NOTICE OF DECISION

HISTORIC DESIGN REVIEW CASE NO.: HIS19-31

SUMMARY: A proposal to install a ductless heat pump system on the exterior of the A. Patrick House (c. 1925).

SITE PLAN

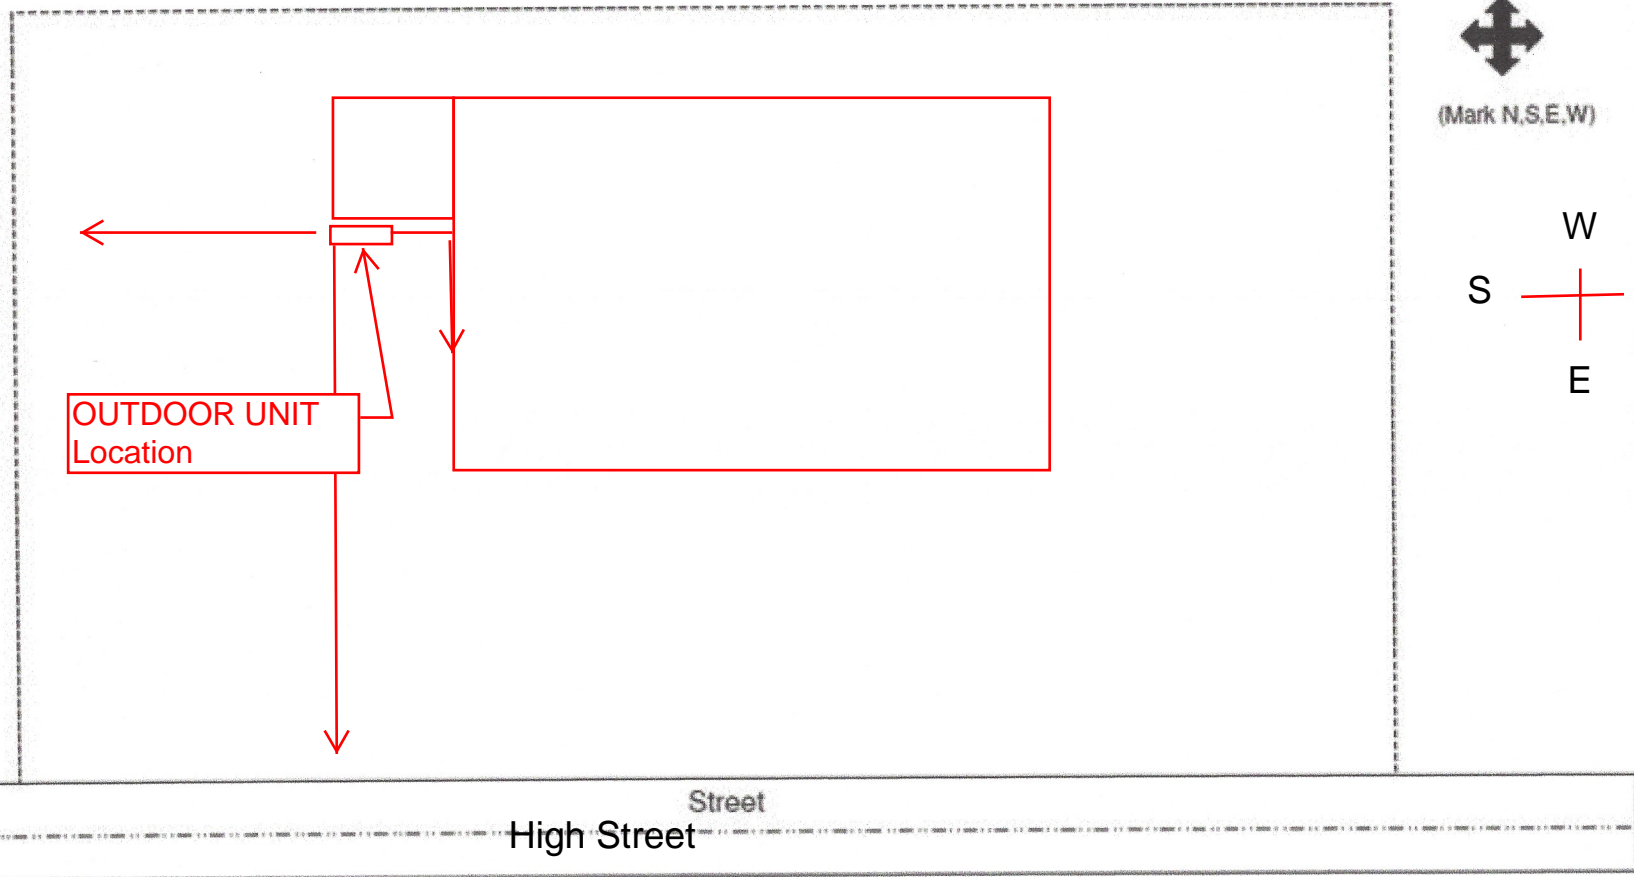
Finding: The applicant is proposing to install the new ductless heat pump near the southeast bay of the A. Patrick House. The outdoor unit will be located within the interior corner of the southern and eastern facades, not attached to the resource. The associated PVC line covers will be installed approximately 15-20 feet along the foundation of the resource and up approximately 15 to 20 feet to the second story along the southern façade of the A. Patrick House, and painted to match the exterior of the resource. These alterations are designed to minimize alterations to the Patrick. A. House, therefore staff finds that this standard has been met.

Finding: The proposed new heat pump compressor is approximately 21" in height and 26" wide. The outdoor unit will be located in the corner of the southern bay of the resource and is screened by bushes. The line sets will run adjacent to the resource behind the bushes, and will extend to the upstairs bedroom on the resource's southern façade. The line set covers can be painted to match the exterior of the resource. The proposed new heat pump is compatible in design and scale with the resource, and the surrounding historic district. Staff finds that this standard has been met.

Outdoor unit

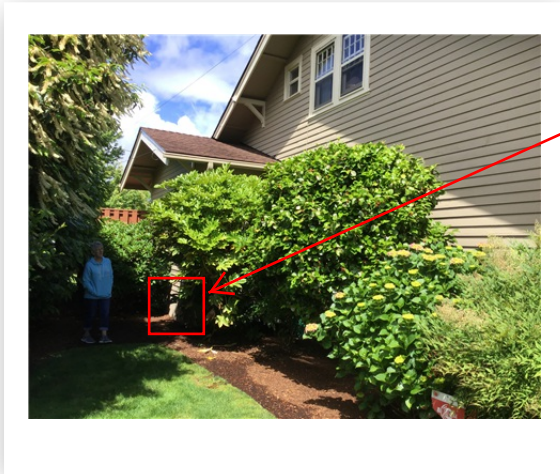
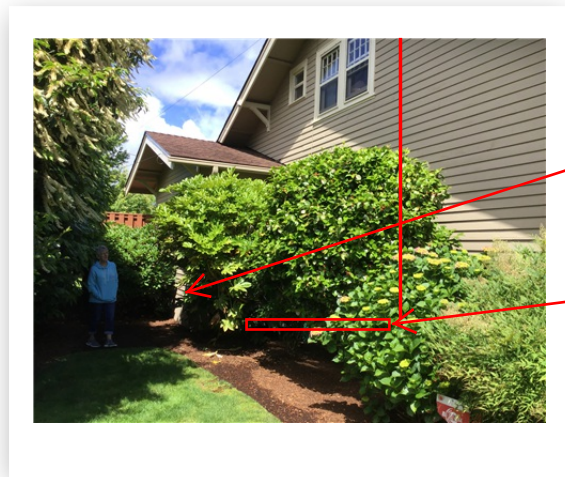
Outside in "flower bed" on ground around corner.

Around corner over up to second floor and to upstairs bedroom unit

Outdoor unit hidden behind bushes from street.

Line sets to run low behind bushes and up to upstairs bedroom and can be painted the same color as house.
